## HISTORIC AND DESIGN REVIEW COMMISSION

January 18, 2023

**HDRC CASE NO:** 2022-596  
**ADDRESS:** 211 W SHERIDAN  
**LEGAL DESCRIPTION:** NCB 930 BLK LOT S 120 FT OF E 50 FT  
**ZONING:** RM-4, H  
**CITY COUNCIL DIST.:** 1  
**HIST. DIST. NAME:** Arsenal Historic District  
**APPLICANT:** Lilian Otterbach, Spensen Management LLC / 615 San Dizier  
**OWNER:** Lilian Otterbach, Spensen Management LLC / 615 San Dizier  
**TYPE OF WORK:** Total Window Replacement  
**APPLICATION RECEIVED:** December 17, 2022  
**60-DAY REVIEW:** Not applicable due to City Council Emergency Orders  
**CASE MANAGER:** Bryan Morales

The applicant is requesting a Certificate of Appropriateness for approval to replace 14 existing wood windows and add one fixed-pane window to the southwest elevation of the house.

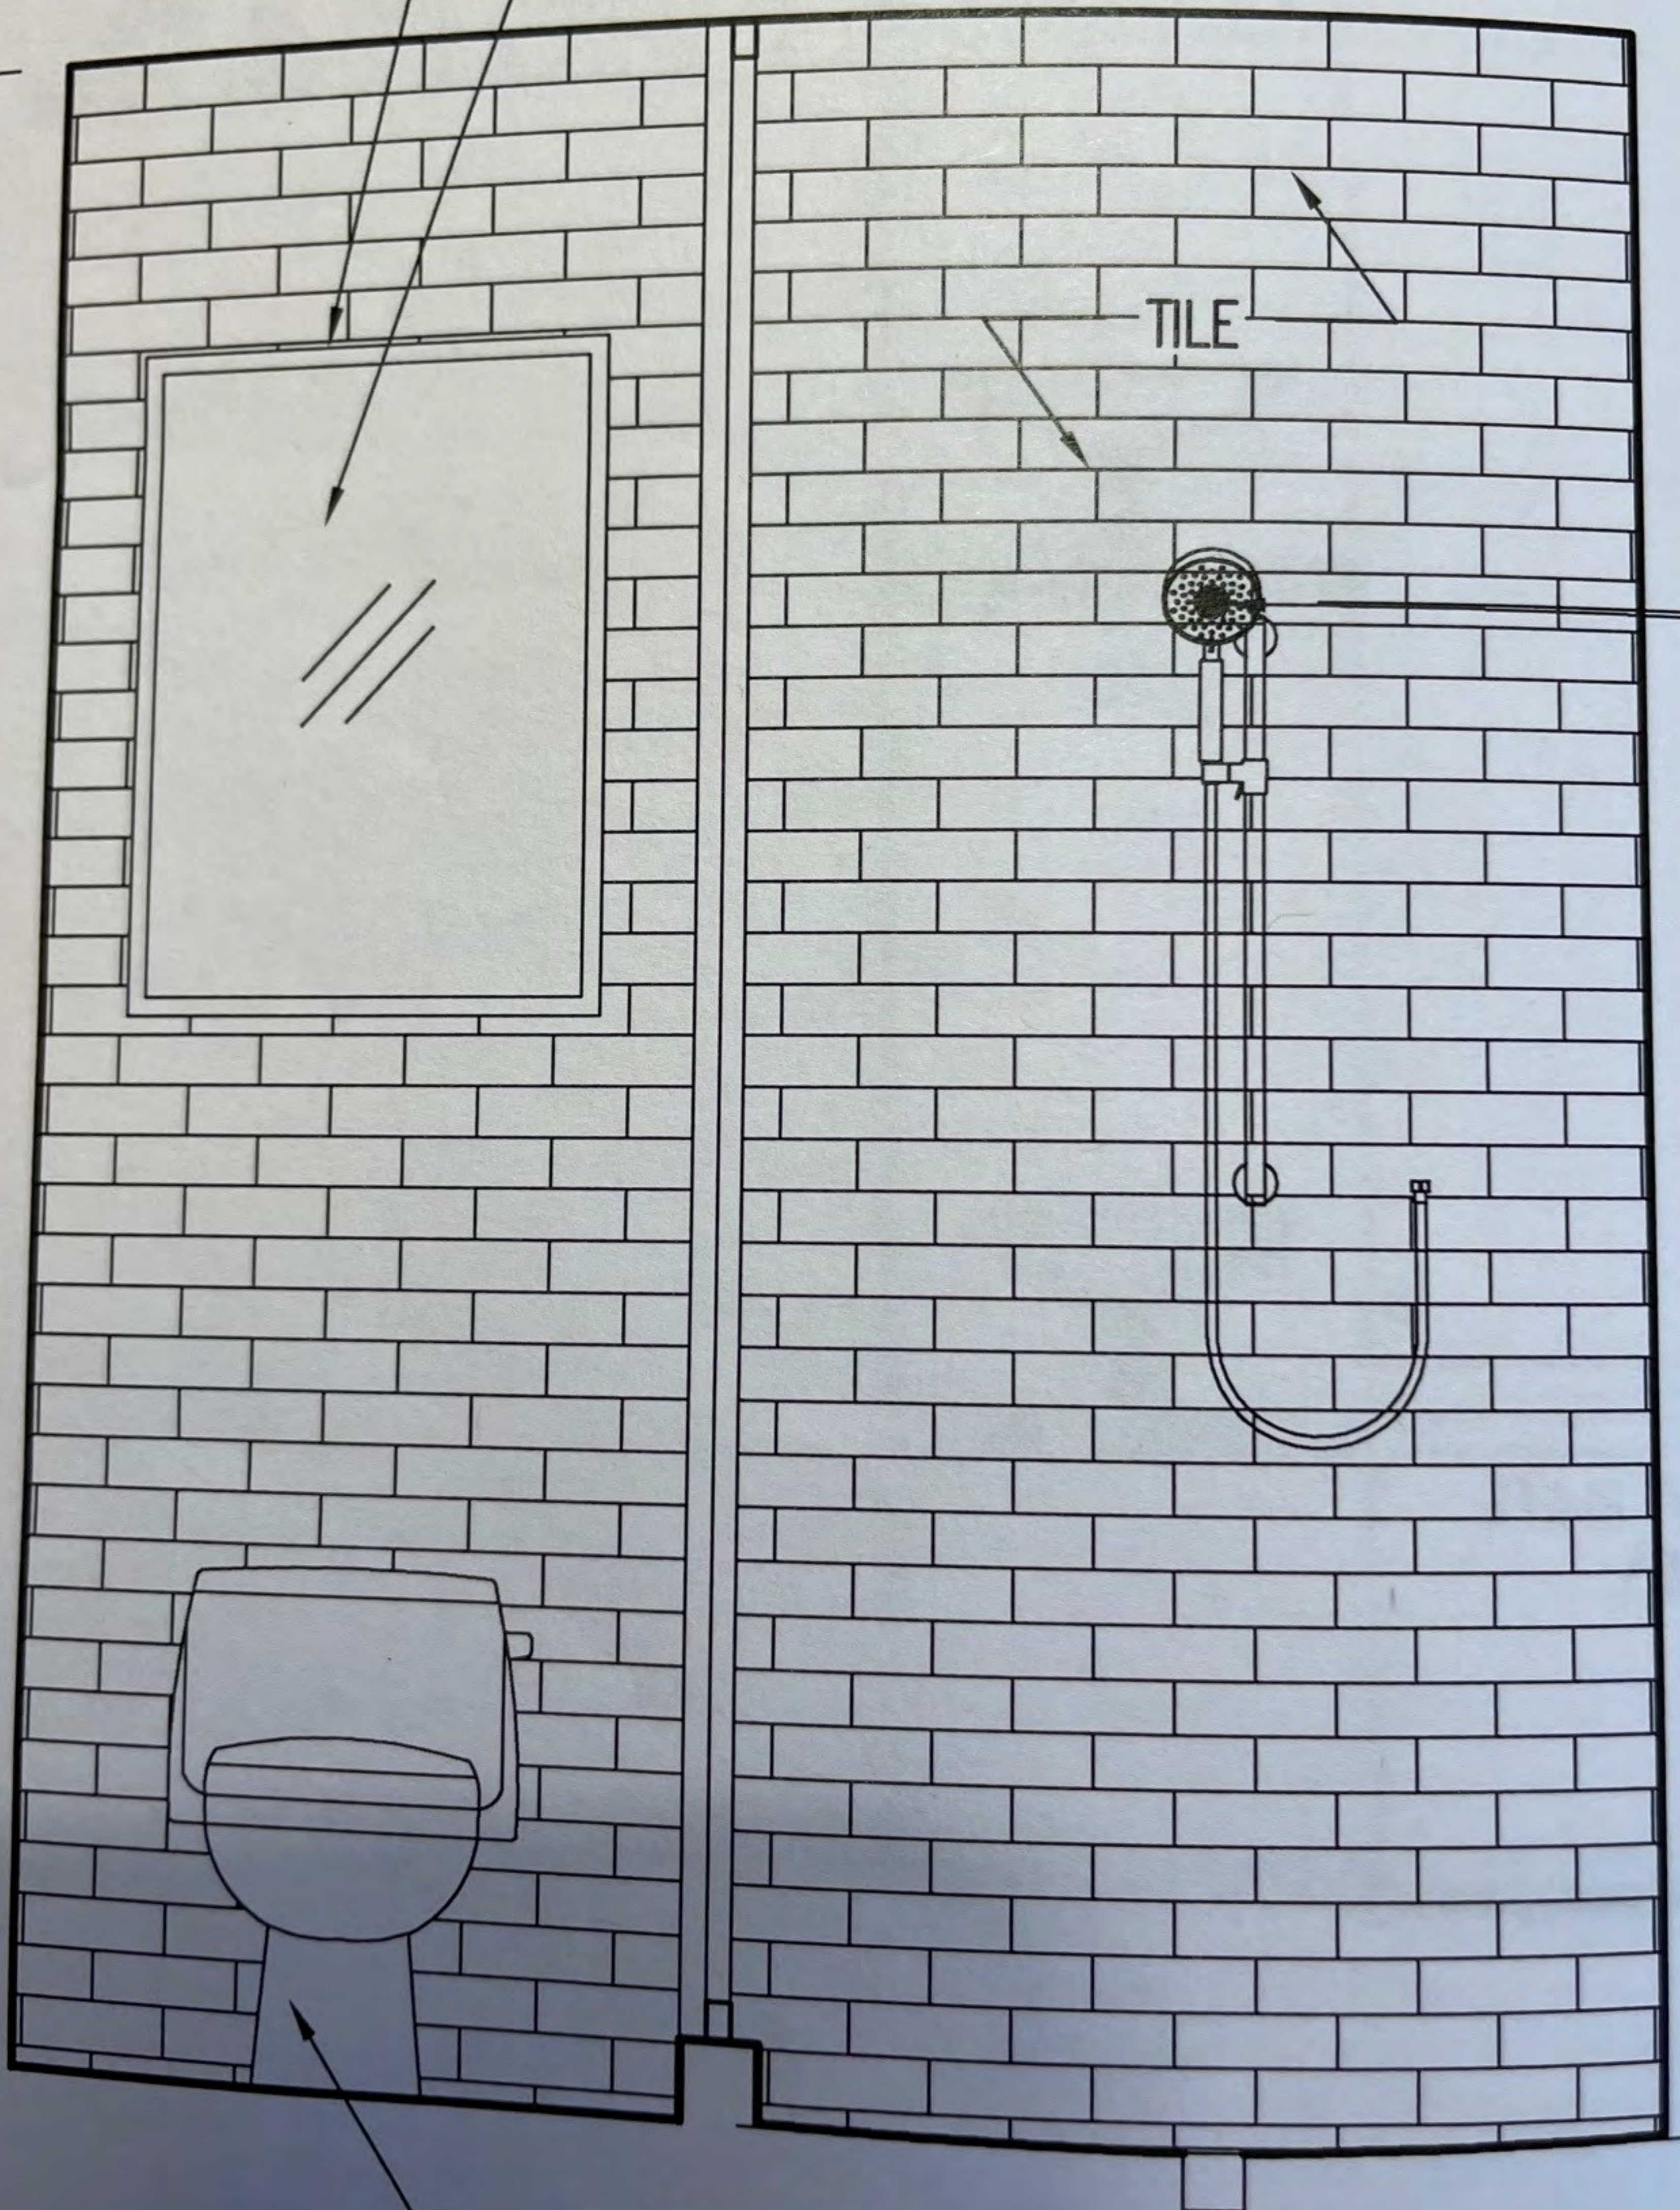
NEW CASEMENT WINDOW  
TO MATCH EXTG

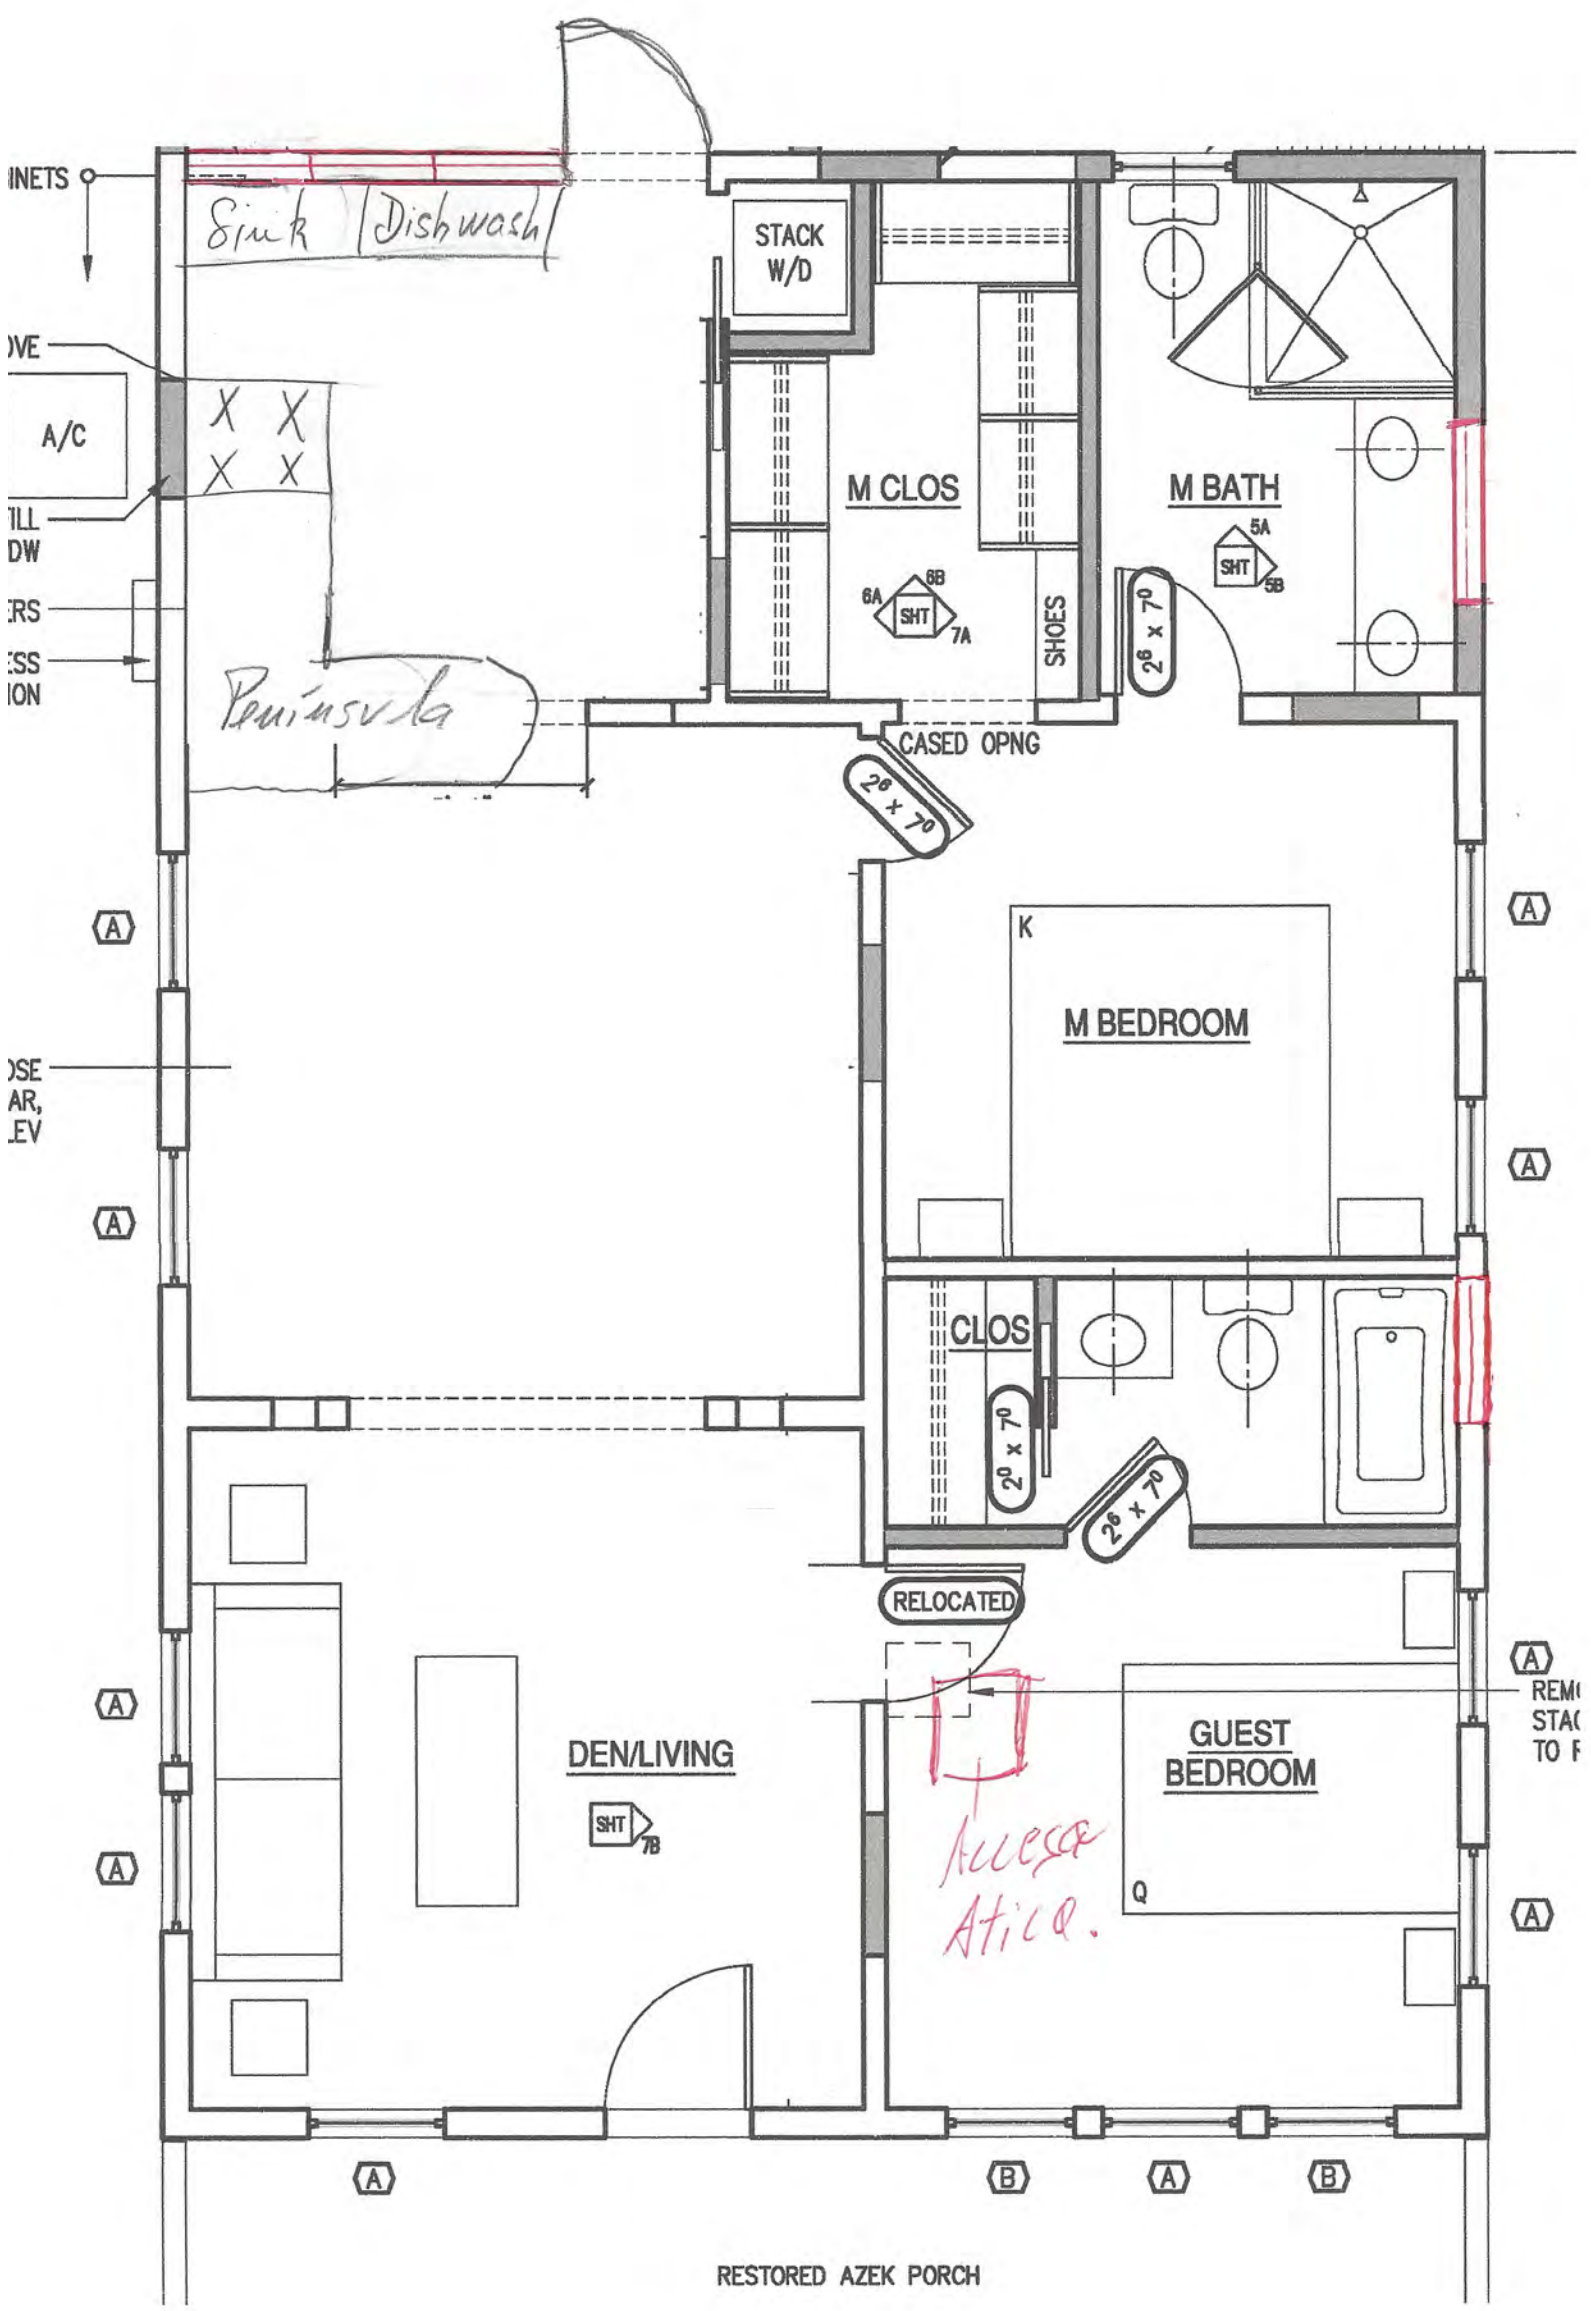
NEW TOILET

\* CLOSE DECK UP WITH SAME SIDING \*

NEW  
WINDOW
